**REVISION TO APPENDIX A: ASBESTOS ABATEMENT DRAWINGS**

LBL ESD  
1st Floor and Basement  
ACM Abatement Locations

LBL ESD  
2nd and 3rd Floors  
ACM Abatement Locations

LINN BENTON LINCOLN EDUCATION SERVICE DISTRICT  
ADMINISTRATION BUILDING  
2022 ABATEMENT PROJECT  
FORM OF PROPOSAL  
SECTION 00 4100  
ADDENDUM 1

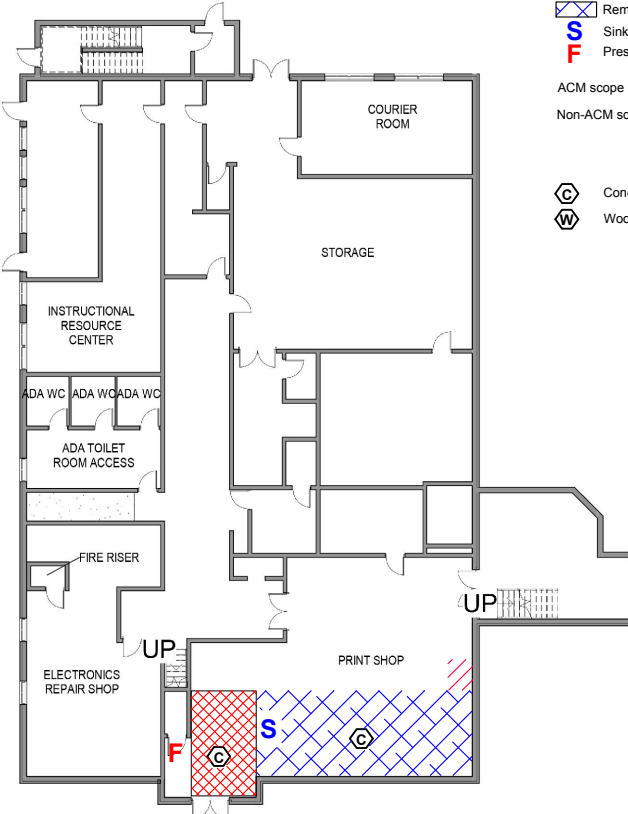
Disregard ***original*** APPENDIX: ASBESTOS ABATEMENTENT DRAWINGS and replace with the attached ***APPENDIX: ASBESTOS ABATEMENTENT DRAWINGS*** in its entirety.

Note: Some of the hatch patterns were shifted off of the drawing due to a CAD error.
